CITY OF ALBUQUERQUE

June 21, 2024

**RE: Quik Trip Store #7001
521 Unser Blvd NW
Conceptual Grading & Drainage Plans
Engineer's Stamp Date: 05/31/24
Hydrology File: K10D071**

Dear Albuquerque Planning Department:

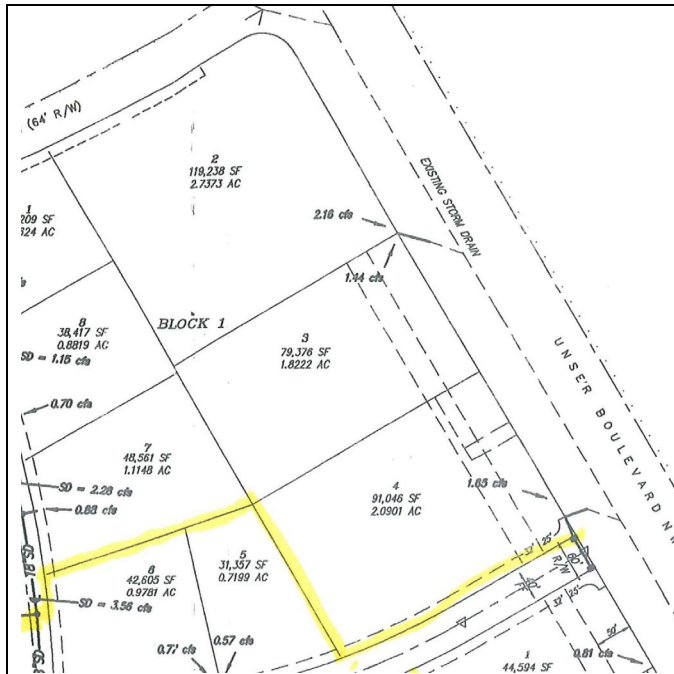
Comment 3:

Please note that this site is also within Clifford West Business Park Master Drainage Plan by Mark Goodwin & Associates dated 1997 (K09D023). Originally, this project area was allowed to discharge 3.60 cfs from 4.56 acers to the back of an existing inlet on Unser Blvd and 1.65 cfs from 2.09 acers to the back of an existing inlet on Unser Blvd.

Then in 2006, Jeff Mortensen & Associated revised this areas drainage so that now a portion of this projects site will drain to Unser Blvd and a portion is to drain to an existing detention pond. However, this revised drainage plan only took this project's site as native vegetative (Type A land type per the City's DPM). It also stated that if this track was to be developed, then the detention pond would have to be resize to handle the developed condition of the site.

It is up to you to either just follow the original Master Drainage Plan that has the allowable rate to Unser's storm drain system or revise the existing detention pond to handle this site's developed conditions.

Response:

Please see the attached drainage summary report. The report shows the historically approved plans for the shared detention basin and shows that the proposed QT development can discharge into the basin without further accommodations. please let us know if you have any questions.

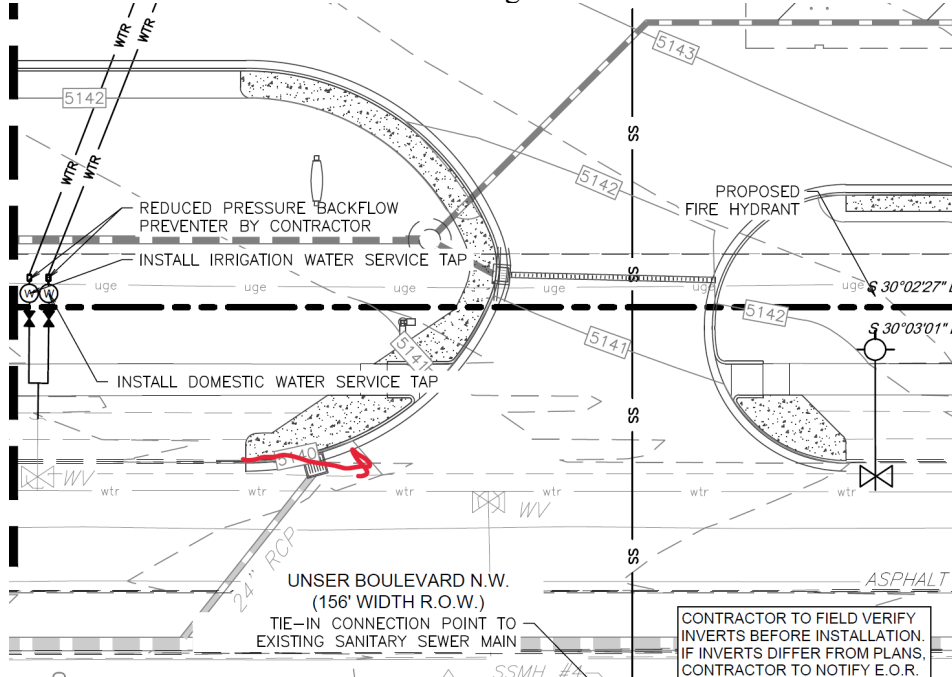
Comment 8:

There is an existing inlet at the driveway location. The entrance needs to shift over about 15 feet to ensure that the back of curb radius is tangent at the inlet's transition section.

Response:

Inlet changed to single combo curb inlet and moved to appropriate location. Manhole added where existing inlet location is.
